## Staff Report to the Zoning Administrator

Application Number: **02-0548**

**Project Description:** Proposal to demolish an existing single family dwelling and construct a new two-story, six bedroom, single family dwelling requiring a variance to: a) reduce the required 20 feet front setback to 0 feet; b) to construct a garage and other improvements within the access corridor, c) *to allow greater than 50% of the front setback area to be used for parking and access (added since previous hearing)*, and d) construct a 5'-10" gate with pillars within the 20 feet front setback.

**Location:** 100 Geoffroy Drive, Santa Cruz

Figure 1. Deck and rear façade of existing residence

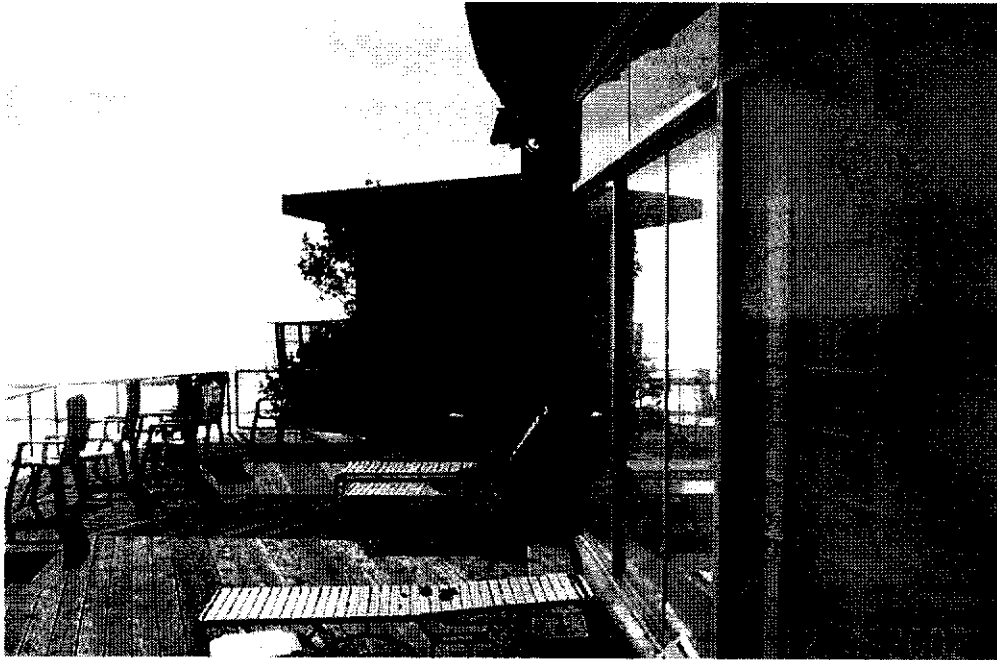
Exhibit *Q* was submitted since the last hearing to demonstrate the logic of the garage location and access, however the setbacks have not been corrected on this exhibit).

PROJECT NO: SC 3516	2005 West Seacore Recon.
DATE: April 2005	Plan View
SCALE: 1 inch = 20 feet	100 Geoffrey Drive
DRAWN BY: DP	Santa Cruz County, CA
HARO, KASUNICH & ASSOCIATES	
FIGURE NO. 1

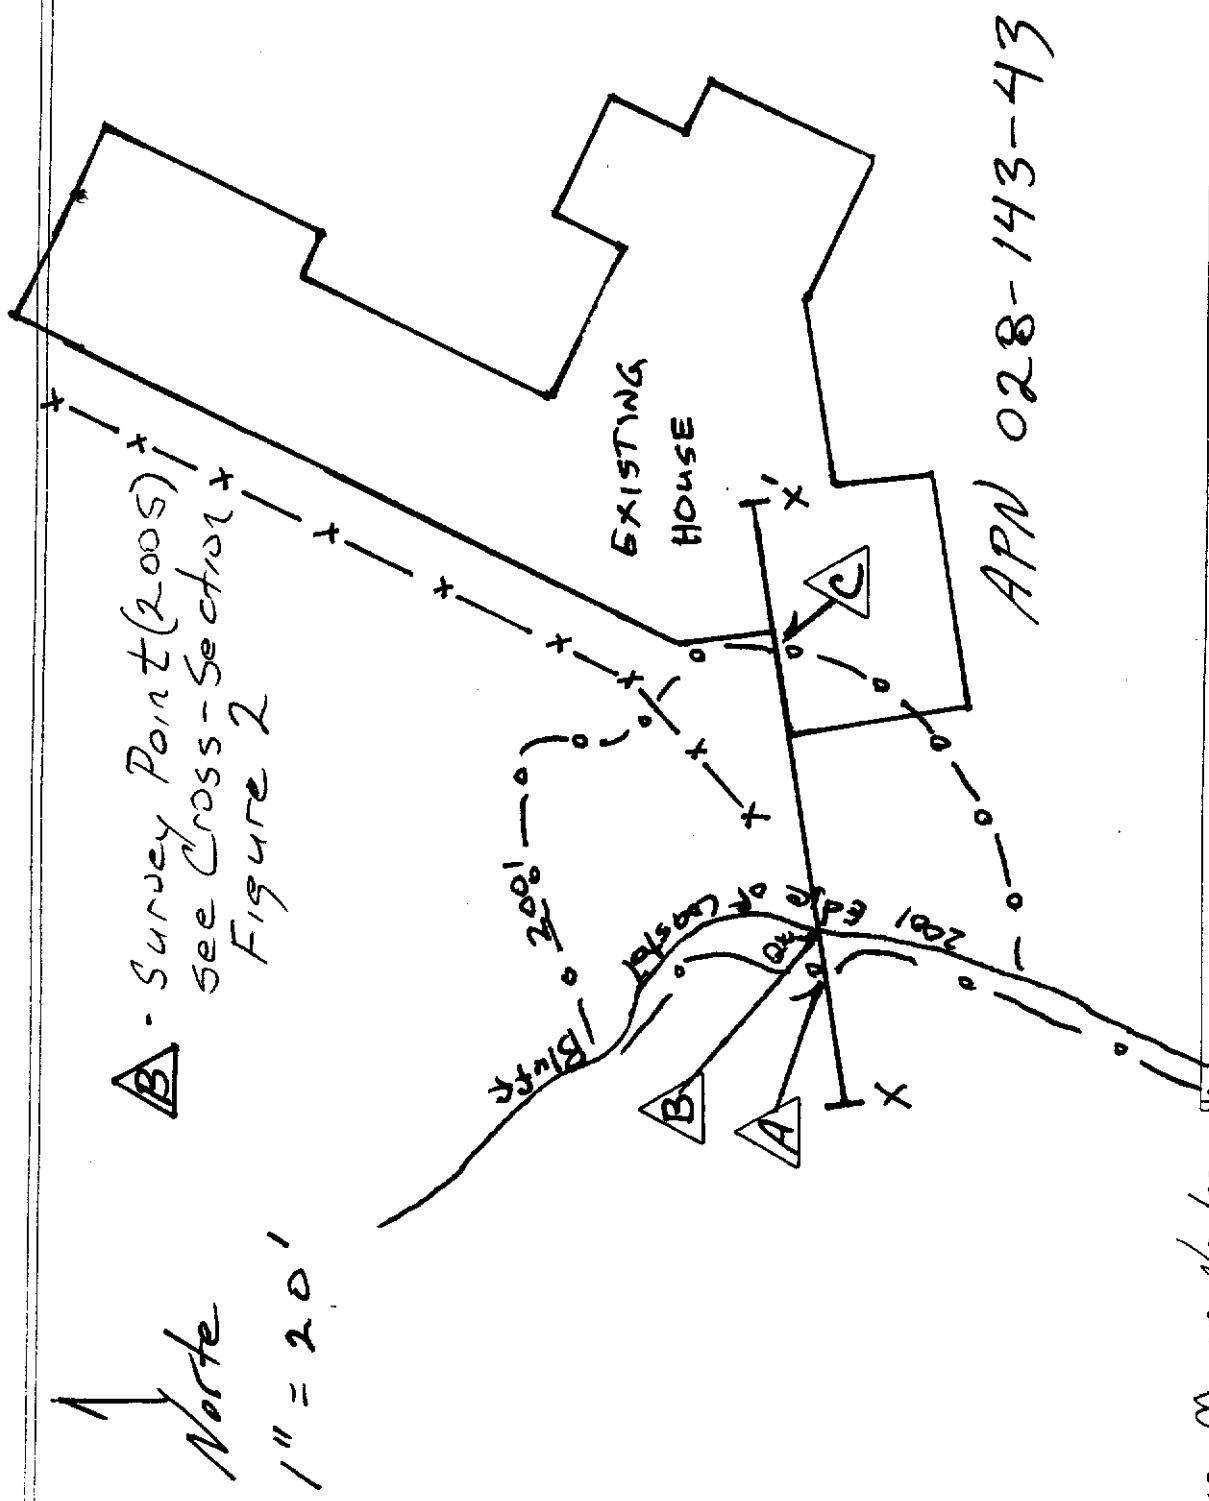
We visited the site on 6 April 2005 to measure the depth of the west perimeter seacave relative to the previously mapped dimension. We measured the seacave in line with the existing structure roof line as shown on Figure 1 included with this letter. We prepared a cross-section, Figure 2, delineating the seacave configuration. We returned to the site on 11 April to measure the blufftop dimensions and complete the cross-section. Also included with this letter are four color plates showing the orientation of our field measurements and the bluff configuration at the time of our site visits, April 2005.
